Re: Second Submission Review: High Point - Catawba and 63rd Parking Lot Site Plan – Site Plan and Replat
Application Number: DA-2233-09
Case Numbers: 2025-6013-00; 2025-3016-00

Second Submission Review

Re: High Point-Catawba and 63rd Parking Lot – 2nd referral, Case # DA-2233-09

Subject: 1882170 – High Point – Catawba and 63rd Parking Lot Site Plan – Site Plan & Replat

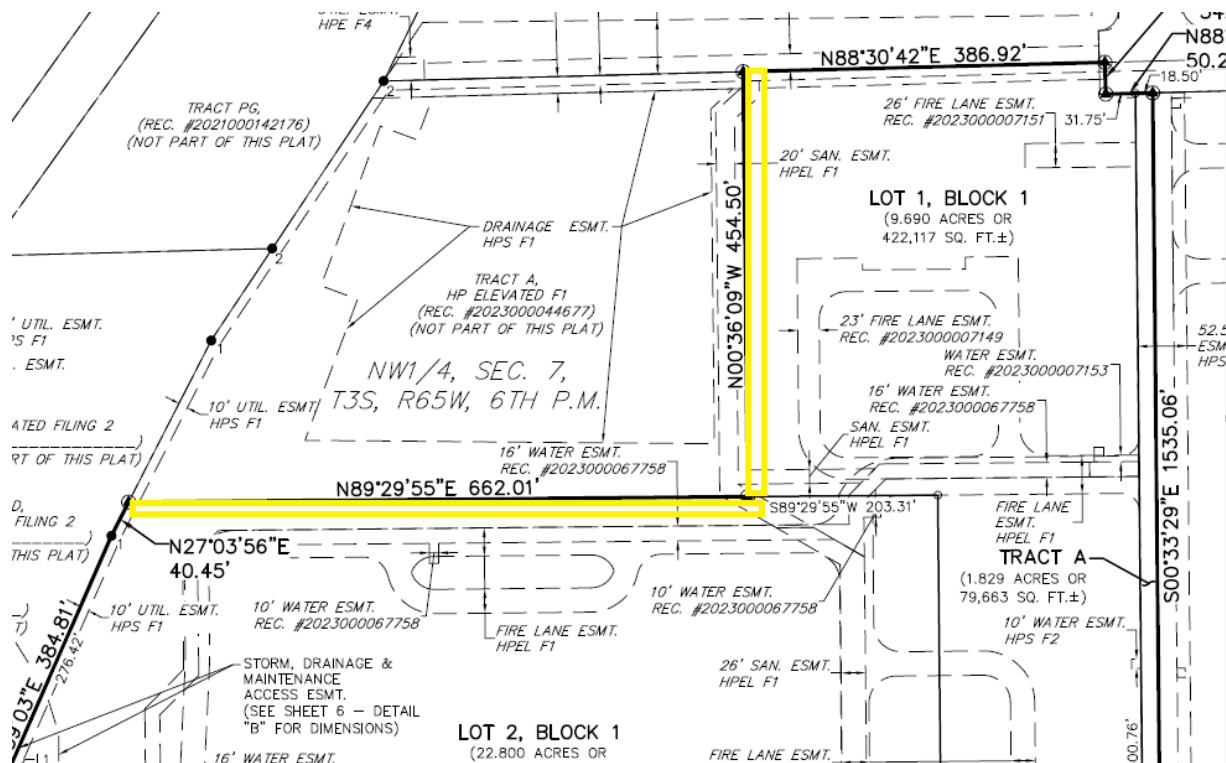
Public Service Company of Colorado's (PSCo) Right of Way & Permits Referral Desk has reviewed the replat and site plan for **High Point-Catawba and 63rd Parking Lot** and has a conflict in that it is still requested that 10-foot-wide utility easements are dedicated on the plat in the areas indicated in yellow below:
